MEMORANDUM

SUBJECT: Public Hearing: Cross Creek Subdivision - Application for Preliminary Plat Approval (File No. 25.2 and 2C)

DATE: February 18, 2002

First Floor

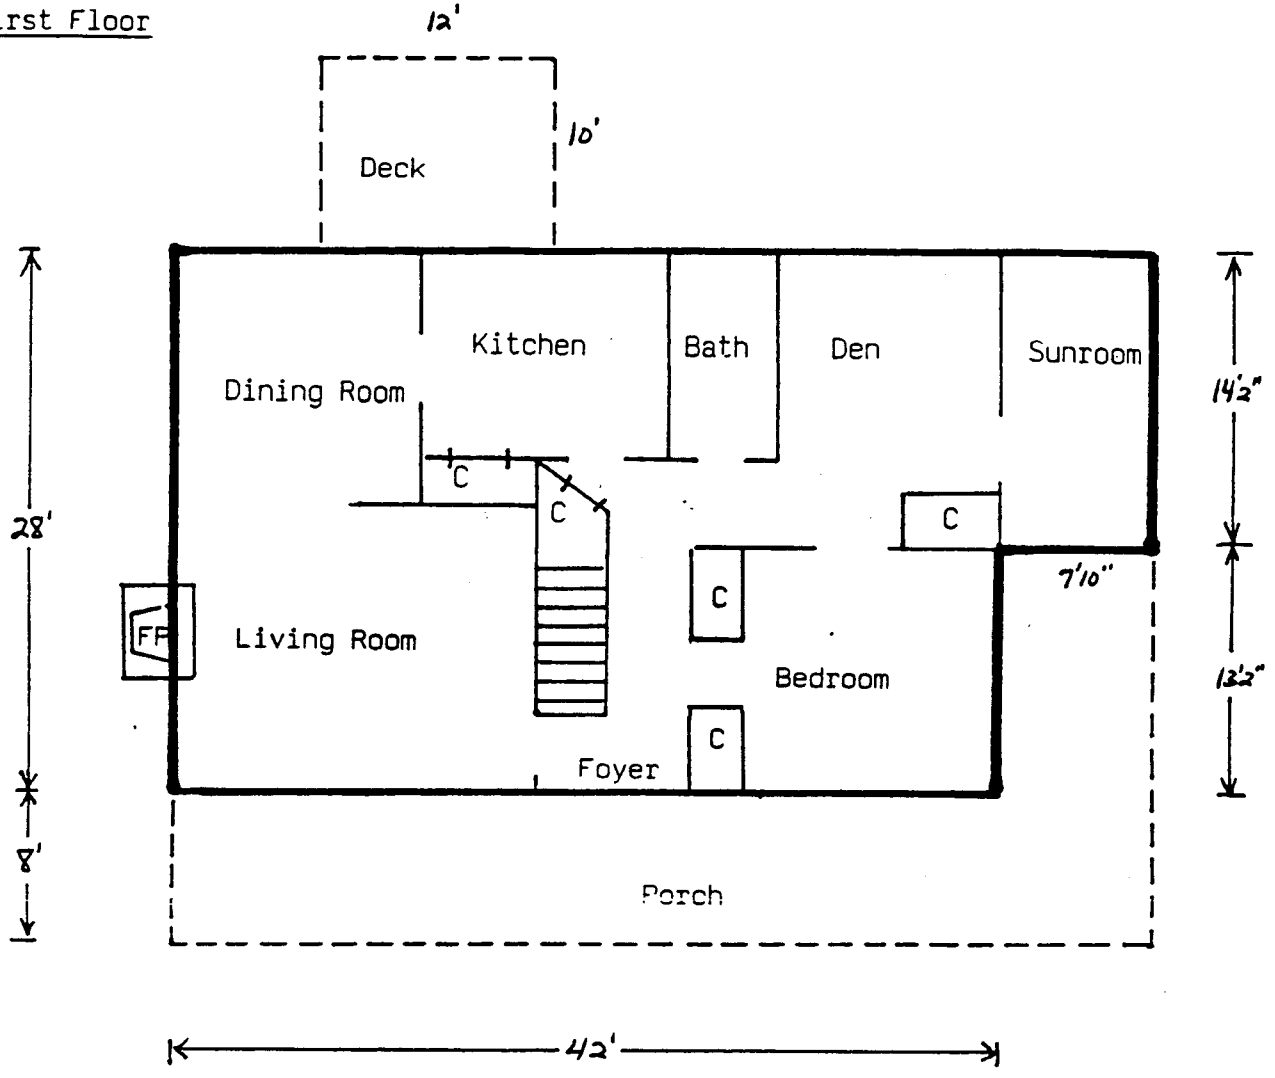
1. Deconstruct the existing stairway to the second floor and replace it with a pull-down ladder; remove all plumbing fixtures from the second floor; and cap the water pipe leading to the second floor; and,

The existing house on the west side of the property is proposed to be part of Lot 1 and the existing house on the east is to be Lot 16. Lot 17 is proposed to be a newly created lot between Weaver Dairy Road and the existing house. Lot 2 is proposed to contain a dwelling constructed of no more than 1,100 square feet of floor area. Both Lot 16 and 17 are planned to be size-restricted to 1,350 square feet each. The developer proposes to reduce the floor area of the existing house on Lot 16 in order to satisfy the limit of 1,350 square feet of floor area.

Comment: We believe that this approach meets the ordinance requirement for restricted house size on the proposed Lot 16. Resolution A, the Manager's preliminary recommendation, would authorize the proposed deconstruction of the existing house.

PRELIMINARY PLAT

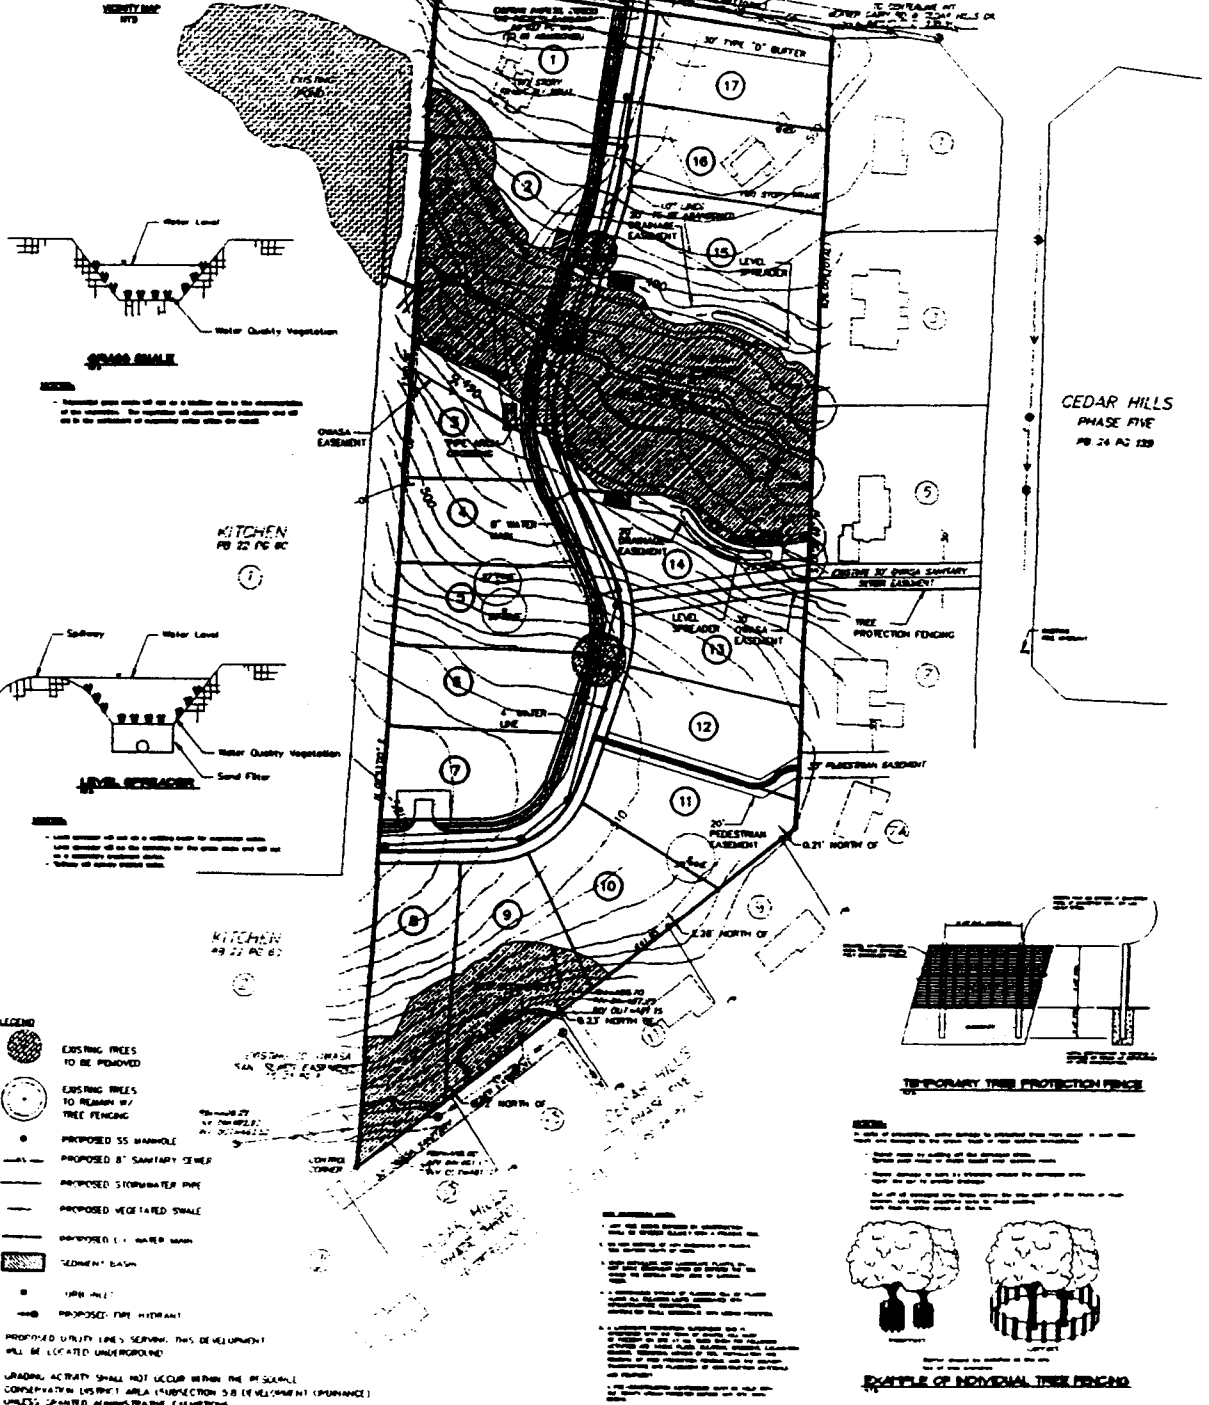
Landscape and Tree Protection: A Landscape Protection Plan has been provided. Two specimen 25-inch diameter at breast height (dbh) pine trees and a specimen 31-inch dbh white oak are proposed to be removed for the construction of the subdivision road. There are few significant trees on the property. All of the significant trees are pines with the exception of the white oak. The white oak is in moderate condition. We have included a stipulation in Resolution A requiring preservation of the 31-inch white oak.

We note that the Resource Conservation District extends onto proposed Lots 2, 3, 8, 9, 10, 14, and 15. We also note that the proposed site plan locates several infrastructure elements, (storm water drainage basins, drainage easements, and sewer lines) in close proximity to the Resource Conservation District boundary. Although not shown encroaching into the Resource

Comment: We have included the stipulation requiring preservation of the 31-inch oak in the Manager's preliminary recommendation, Resolution A. It is a specimen deciduous tree in moderate condition. It is also the only deciduous tree on the property of such proportion. The subdivision road realignment would change the configuration of several lots on the southern portion of the site. Resolution A requires the retention of the white oak tree and that the applicant include tree protection fencing around the critical root zone of the tree as a part of a Landscape Protection Plan.

5. Weaver Dairy Road Right-of-Way: That the applicant shall dedicate an additional 15 feet of right-of-way along the Weaver Dairy Road frontage.
6. Alternative Road Design for White Oak Tree Protection: An alternative subdivision road design shall be provided which would preserve the 31-inch white oak tree. The applicant shall include tree protection fencing around the critical root zone of the tree as part of the Landscape Protection Plan.

CROSS CREEK
 Seas Development Company, Inc.
 PRELIMINARY PLAT
 CHAPEL HILL, NORTH CAROLINA
**PRELIMINARY UTILITY, DRAINAGE,
 EROSION CONTROL, AND
 LANDSCAPE PROTECTION PLAN**

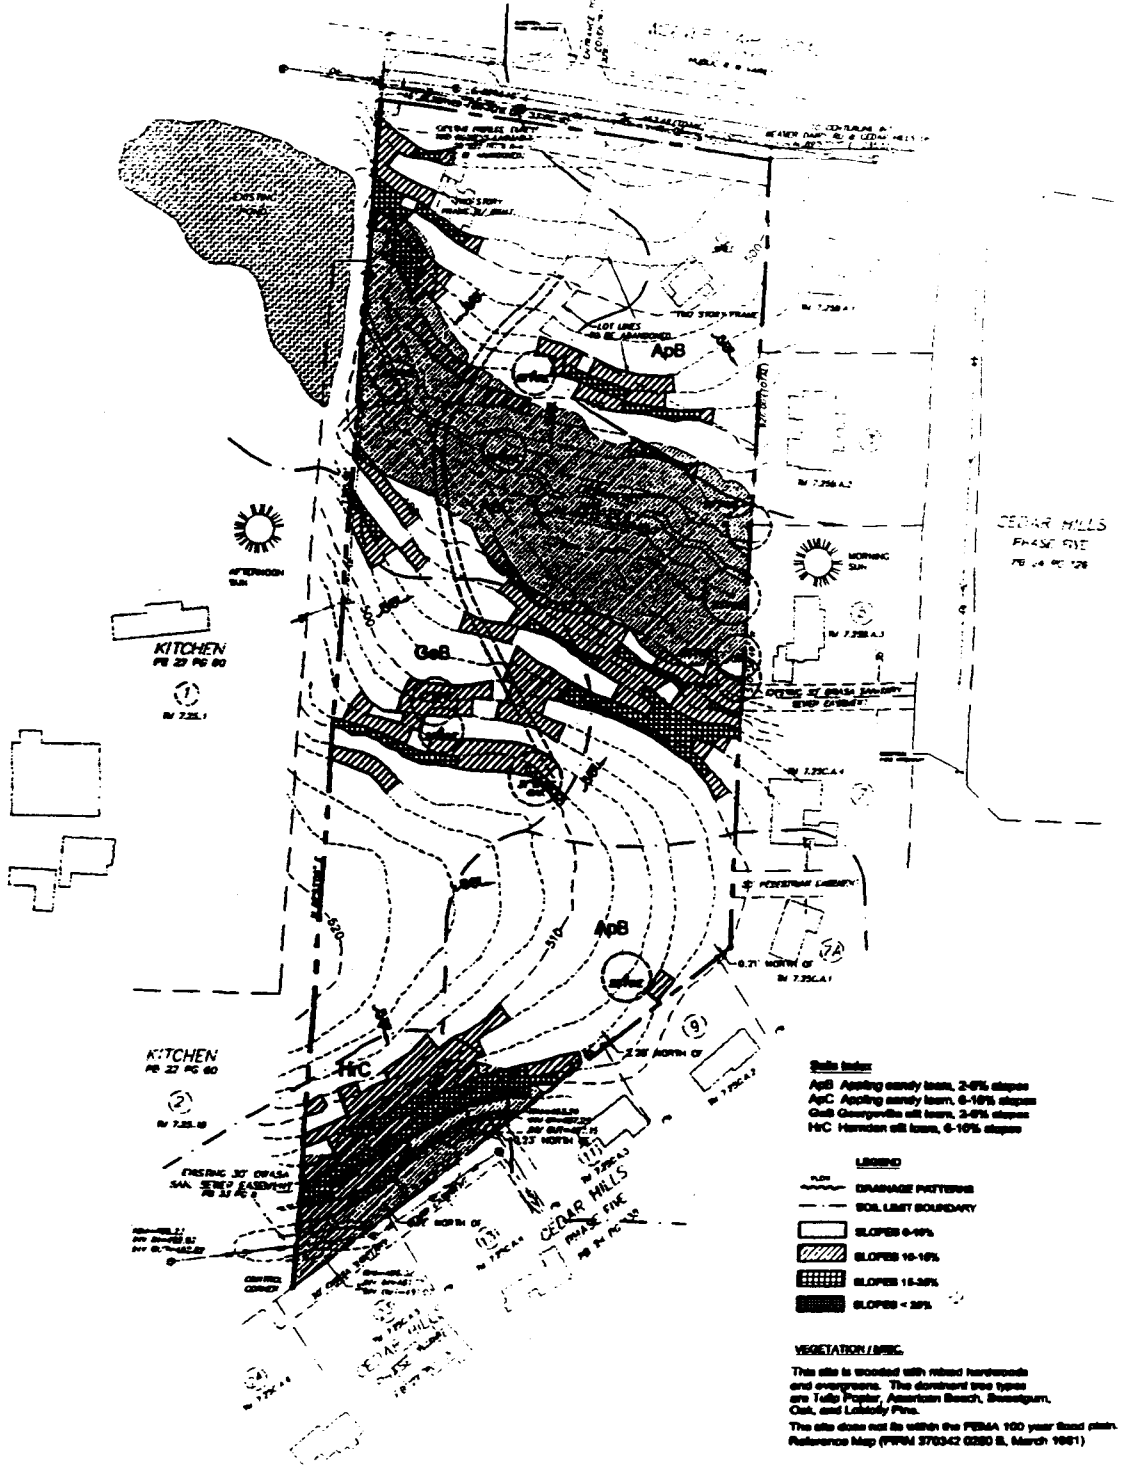
5. Location of the Drainage Easement: The drainage easement located along the eastern top of the Resource Conservation District buffer, is shown on the plans as being 30 feet in width overall, with 20 feet outside the Resource Conservation District and 10 feet inside the Resource Conservation District. The drainage easement is proposed to contain constructed stormwater facilities, vegetated swales and level spreaders.

Comment: The Development Ordinance requires that land disturbance proposed in the Resource Conservation District shall be kept minimal. We believe that for maintenance of the proposed stormwater structures, 10 feet must be available for equipment to clean, regrade, and perform regular maintenance of these structures to ensure effective functioning. We recommend that the drainage easement be located entirely outside the Resource Conservation District in order for the Resource Conservation District to remain undisturbed. Resolution A includes a stipulation to this effect.

Comment: We have included this stipulation in the Manager's preliminary recommendation: The 30-foot drainage easement along the eastern top of the Resource Conservation District must have its full 30 foot width entirely out of the Resource Conservation District. It is anticipated that routine maintenance will require 10 feet around the constructed stormwater drainage structures. Given the area required for maintenance and to minimize land disturbance in the Resource Conservation District, the storm drainage easement should be located entirely outside the Resource Conservation District.
